Objection to Planning Application <sup>150765</sup>~~150764~~ - Chester Hotel

**CHESTER HOTEL-Application Number 150765**

**Planning application – PL40990**

**Residents of 26 Harlaw Road – comments on the Noise Report**

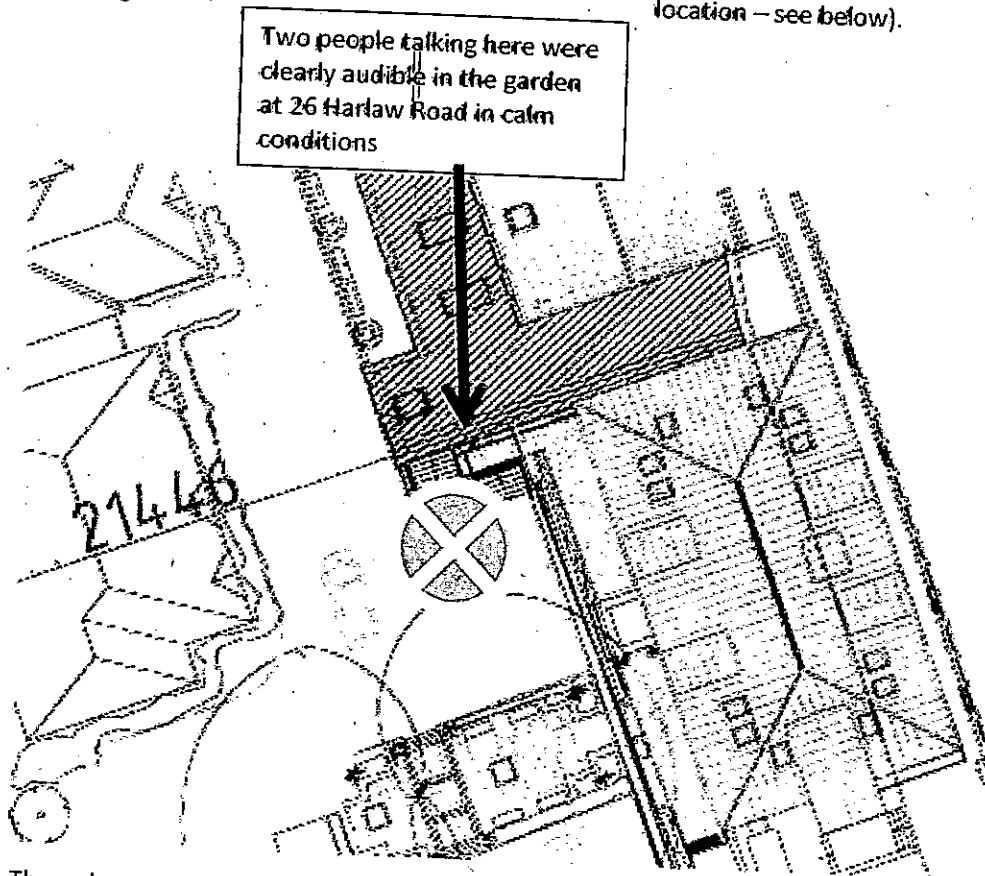
We have lodged objections to the granting of a licence for the raised balcony area adjacent to the hotel restaurant which was constructed last year instead of the pitched roof which was on the approved plans. The balcony, which is at a considerable height, was being used for the consumption of alcohol until the planning department became aware of the unauthorised construction. Not only does this show a blatant disregard for the planning and licencing authorities by the hotel management but it raises questions about public safety (for instance escape routes in the case of a fire). The Chester Hotel have now retrospectively applied for planning and licencing consents for the elevated balcony. This is the second instance of retrospective planning and licencing applications by the Chester Hotel during the last year, the previous applications including an outdoor seating area and pergola in the rear car park.

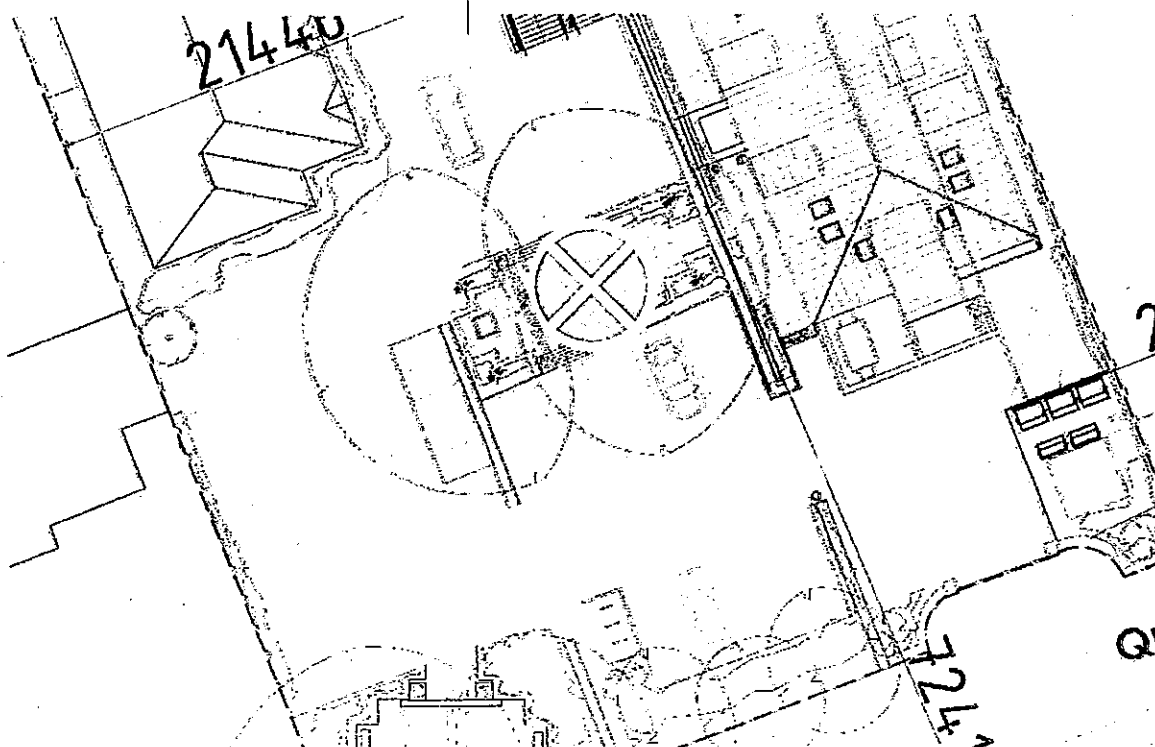
However, when the methodology is applied to the previously approved outdoor seating area there is a significant problem. See the calculation below.

External Seating Area (marked on plan above) Noise Predictions			
	Chester RMP Report methodology – 25 persons	Assessment by A West – 25 persons	Assessment by A West – 50 persons
	L <sub>Aeq,t</sub>	L <sub>Aeq,t</sub>	L <sub>Aeq,t</sub>
Raised speech noise level (1 person)	66	66	66
People talking	80	80	83
Distance attenuation (15m)	-23	-23	-23
Partial acoustic screening	-0	-0	-0
Predicted external free field	<b>57</b>	<b>57</b>	<b>60</b>
Existing ambient level	51	47# (Estimated)	47# (Estimated)
Correction for non-free field	-1? -2.5?*	-0	-0
Corrected ambient level	<b>50 to 48.5</b>	<b>47</b>	<b>47</b>
Exceedance of existing noise level	<b>7 to 8.5</b>	<b>10</b>	<b>13</b>

The effects of the two noise levels are cumulative – therefore the total noise level will increase by between 11.5 and 14.5 dB.

It can be clearly seen that the existing outdoor seating area is already generating too much noise on the above assessment. Last autumn we have already had experience of this noise from the outside seating area which is in direct line of sight of the garden at 26 Harlaw Road. The noise from the balcony would be in addition to this existing noise and would therefore further impact on the amenity of the area and disturb the residents, causing a change in their behaviour.
